Service Bulletin

PRELIMINARY INFORMATION

Subject: Intermittent Gauges Drop and/or Radio and HVAC Displays Blank Out When Passenger Seat is Occupied

Models: 2013 Chevrolet Malibu
Built Prior to March 14, 2014

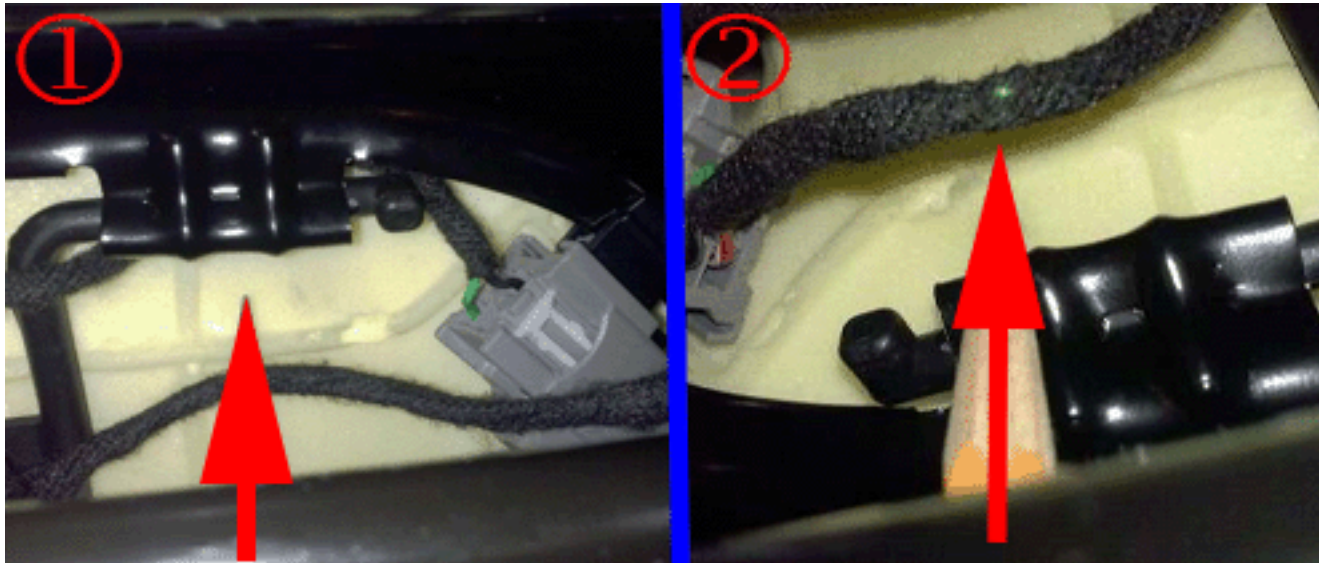
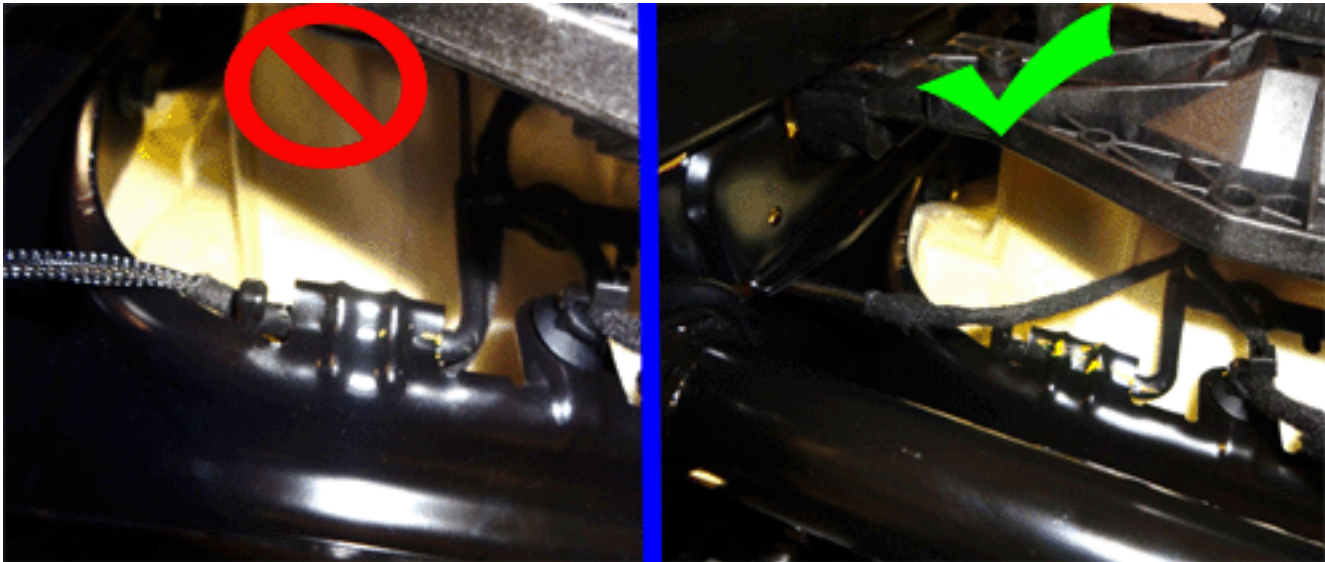
This may be caused by a chaffed wire or short to ground in circuit 5060 from X320 cavity 7 to the Passenger Presence Sensor.

2. With the seat removed, visually inspect the passenger presence sensor harness for chaffing or exposed bare copper wire.

3. If there is chaffing or exposed copper wire, re-wrap the area with anti-abrasion tape or equivalent.

4. After wrapping the area, re-route the harness away from the seat frame as illustrated above.
